HISTORIC LANDMARK COMMISSION

APPLICATION FOR A PERMIT WITHIN A NATIONAL REGISTER HISTORIC DISTRICT DECEMBER 14, 2020 610 BRAZOS STREET SIXTH STREET NATIONAL REGISTER HISTORIC DISTRICT

Paint a mural on the sides of the building.

Current photograph, December, 2020 (by staff)

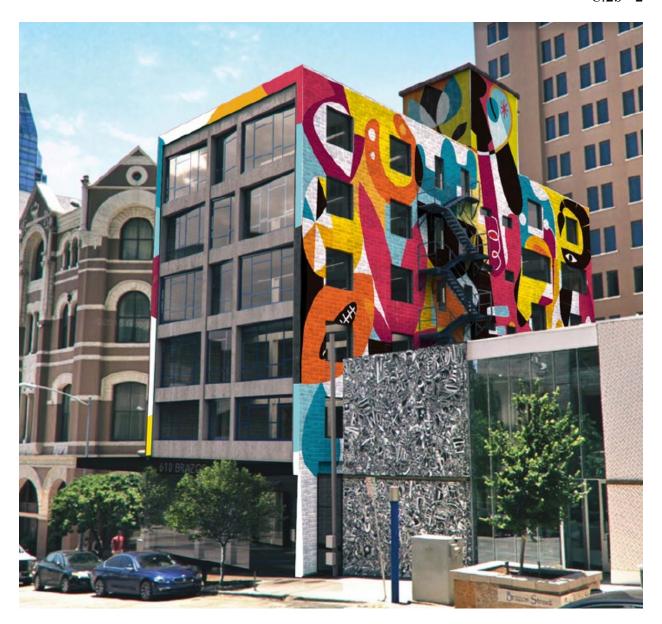
The proposed mural will be painted on the north wall of the building and the mechanical structure on the roof; it will slightly wrap around the sides of the front wall of the building. Like the proposed mural at 506 Congress Avenue, this mural was designed by renowned Spanish artist Ruben Sanchez; Here is his website https://www.iamrubensanchez.com

Staff recommends approval of this mural with the added requirement that the applicant complete a maintenance plan. This proposed mural differs significantly from the proposed mural for 506 Congress Avenue in that it is painted on the side of the building rather than the primary façade, and the building is clearly non-contributing to the historic district. There is a precedent for other murals in downtown Austin that have been applied to side walls of the building. Although the size of the mural may be an issue, this proposed mural is more in line with the principles set forth in the City of Milwaukee's guidelines for murals in historic districts.
